Department
for Transport

Interim changes to the Guidance on the use of Tactile Paving Surfaces

August 2015

Figure 1.1: Treatment of an uncontrolled crossing point at an irregular corner under the existing tactile guidance (left) and under the proposed amendment 1.1 (right).

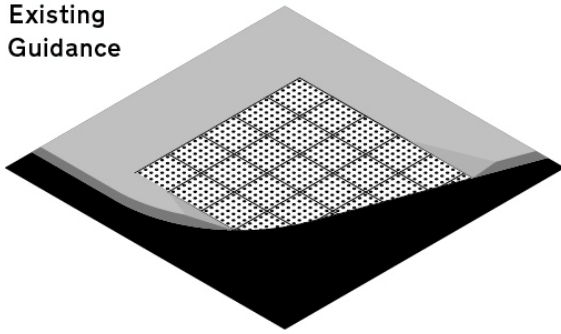
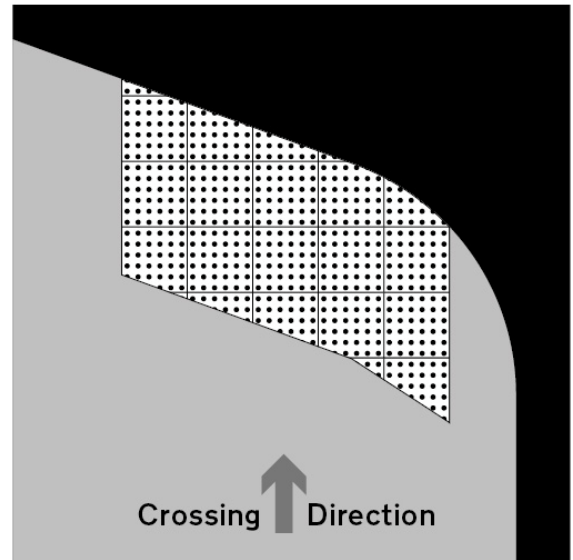
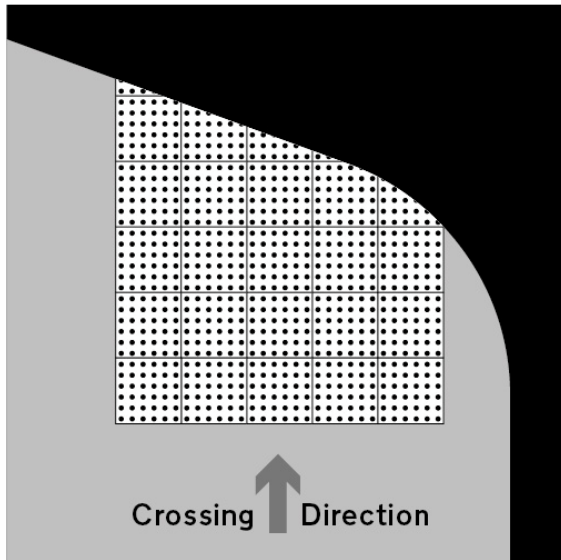
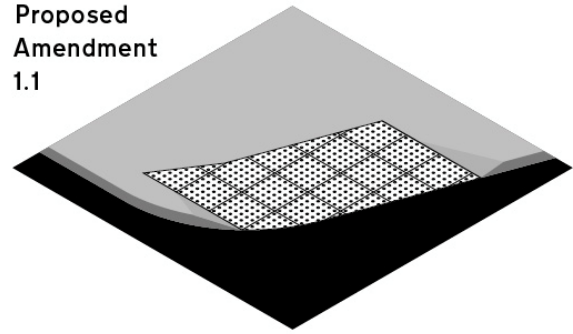
5.1 Replaces:

“The back edge (of the section of tactile surface which extends across the dropped kerb) should be at right angles to the direction of crossing (Figure 3 page 29). This may not necessarily be parallel to the kerb.” 1.5.1.2 (p28)

It was acknowledged by workshop participants that the expansive trapezoidal areas of blister surface, created by the strict application of the perpendicular back edge rule at many irregular crossing points, were not providing the accurate orientation information many people with sight impairments need to navigate. It was felt that the increase in accuracy and specificity that would be provided by a smaller, simpler area of blister surface would justify the loss of the information provided by the perpendicular back edge.

The back edge (of a section of tactile surface marking the boundary between the footway and carriageway) should be parallel with the boundary and set back in the direction of crossing by a fixed distance (typically 800 mm or 1200 mm).

This change should not affect the practice of laying the tactile surface so the blisters are aligned parallel to the direction of crossing nor the requirement for the provision of a stem at controlled crossing points 1.5.1.2 (p30).

Figure 1.2: Treatment of an uncontrolled crossing point at an irregular corner under the existing tactile guidance (left) and under proposed amendment 1.2 (right).

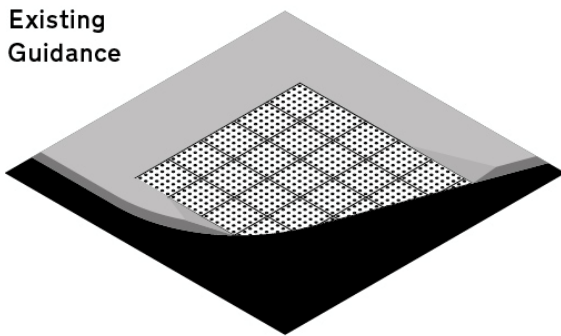
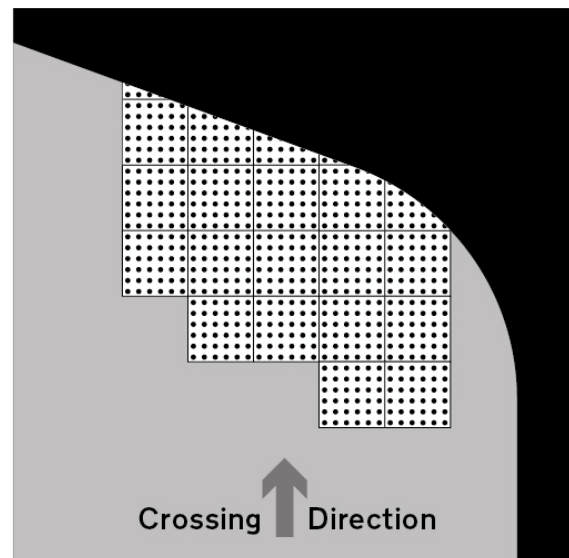
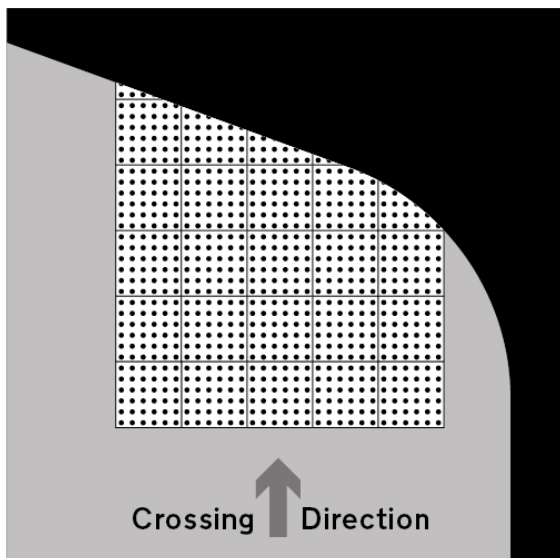
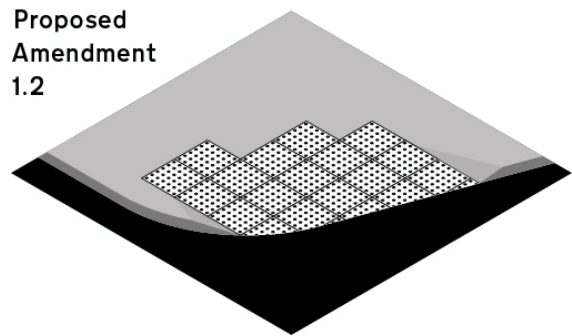
5.4 Replaces:

“The back edge (of the section of tactile surface which extends across the dropped kerb) should be at right angles to the direction of crossing (Figure 3 page 29). This may not necessarily be parallel to the kerb.” [1.5.1.2 (p28)]

It was acknowledged by workshop participants that the expansive trapezoidal areas of blister surface, created by the strict application of the perpendicular back edge rule at many irregular crossing points, were not providing the accurate orientation information many people with sight impairments need to navigate. A stepped approach would reduce the requirement for tactile tiles to be cut to match the kerb profile at the back of the installation (as they already are at the front).

The back edge (of a section of tactile surface marking the boundary between the footway and carriageway) should approximate the line of the boundary using a stepped approach with the appropriate minimum distance (typically 800 mm or 1200 mm) maintained but in some places increasing so that the back edge of each individual tile remains perpendicular to the direction of crossing.

This change should not affect the practice of laying the tactile surface so the blisters are aligned parallel to the direction of crossing nor the requirement for the provision of a stem at controlled crossing points 1.5.1.2 (p30).

Figure 2.1: Images showing different combinations of colours of tactile paving and surrounding paving with their measured contrast ratios.

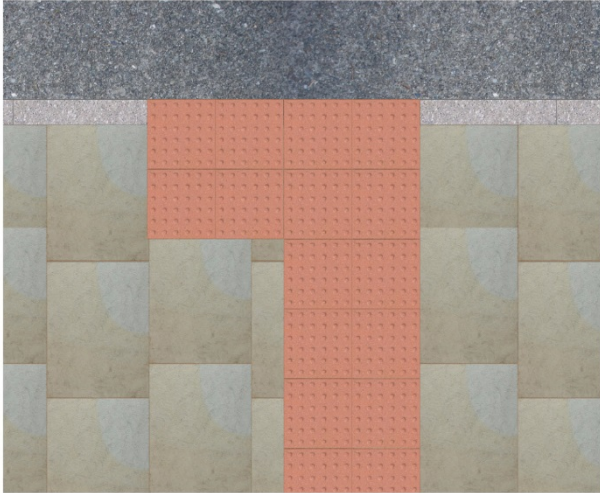
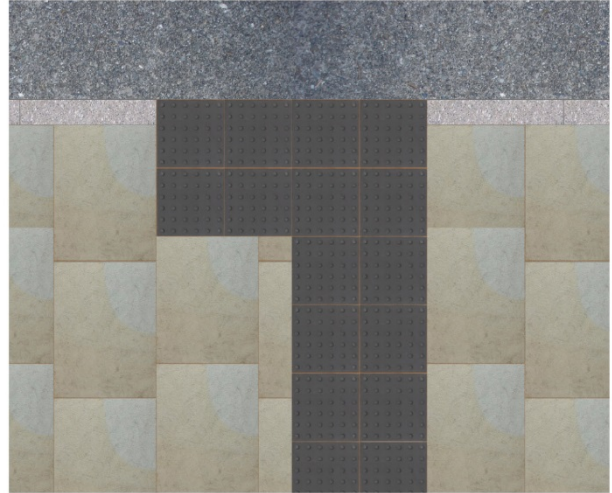
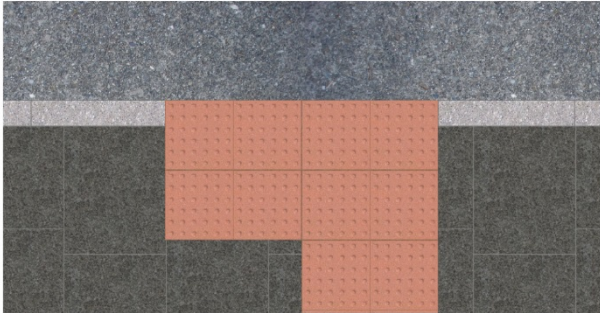
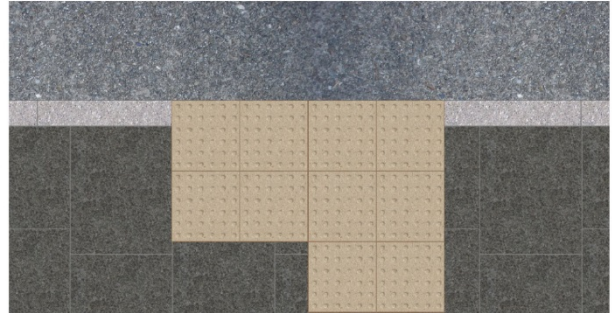
6.1 Replaces:

“The red blister surface should be used at controlled crossings only.[...] It is best to avoid using any other red material in the vicinity of a controlled crossing. Where this is unavoidable it will be necessary to provide a contrasting border around the blister surface contrasting in colour and tone. A border 150mm wide should provide sufficient contrast. Where there are conservation considerations an alternative colour for the tactile surface may be appropriate (see 1.5.6).” 1.5.1.1 (p28)

“Where the blister surface is provided at crossing points in conservation areas or in the vicinity of a listed building, some relaxation of the colour requirements may be acceptable. In these limited circumstances only, the tactile surface may be provided in a colour which is in keeping with the surrounding material.” 1.5.6 (p51)

Workshop participants felt that for the majority of street users with low vision colour contrast provided more assistance than the presence of a specific colour (particularly a colour so close in tone to common paving materials such as Yorkstone). Adoption of a specified minimum contrast ratio should ensure consistency in the presence of this contrast whilst providing designers freedom to design in sympathy to local context.

The tactile surface used to indicate the presence of a controlled crossing should provide a contrast ratio of at least 50% to the surrounding paving in both wet and dry daylight conditions and when illuminated by the adjacent street lighting at night.

Figure 3.1: Proposed deployment of tactile surface(s) in level surface contexts

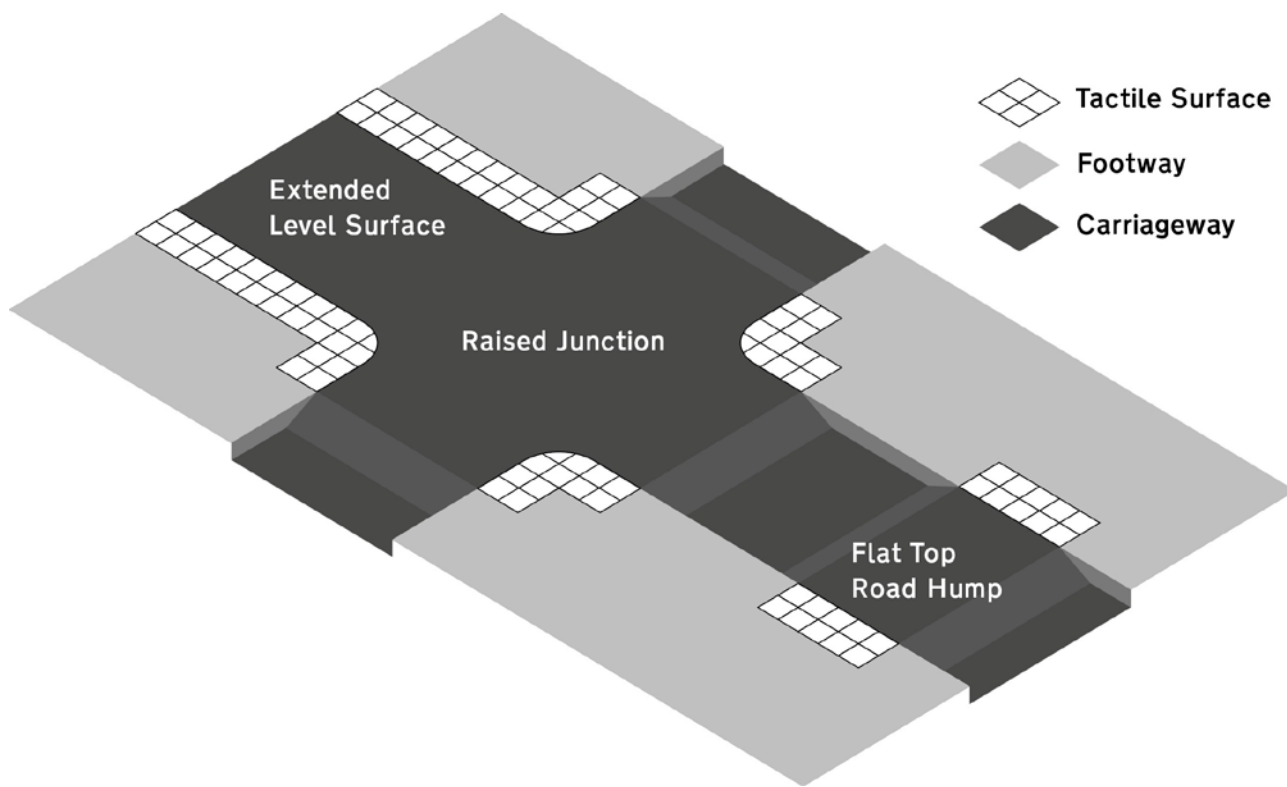
7.1 Replaces:

“Where an extensive area of the carriageway has been raised then it will not be appropriate to install the tactile surface along the full length. In those circumstances the tactile surface should be limited to the ‘crossing’ area (Figure 15 page 49), and the remaining raised carriageway either side of the tactile surface should maintain a level difference with the footway of at least 25mm high or have a continuous physical barrier, for example, planters, railings” 1.5.5.1 (p48) [...] “Where the carriageway has been raised to the level of the footway around an entire junction, it is essential that visually impaired pedestrians are kept away from the radius by the use of continuous physical barriers, for example, guard railings (Figure 17 page 50).” 1.5.5.3 (p48)

Workshop participants agreed that there needed to be a simple, unambiguous rule to prevent the appearance of un-delineated level surfaces (for example where designers implemented the raised junction treatment described but omitted the guard railings). Research has indicated that 60mm is the minimum level change that can be reliably detected by people with sight impairments in the absence of tactile paving whilst 800mm is the minimum depth of tactile paving that can be reliably detected.

Wherever there is no level change between carriageway and footway, or a level change of less than 60mm, the boundary between footway and carriageway should be delineated with a tactile surface of at least 800mm in depth. This rule should apply to any continuous barrier-free surface occupied by pedestrians and vehicles be that a flat top road hump, a raised side road or junction, or an extended level surface area.
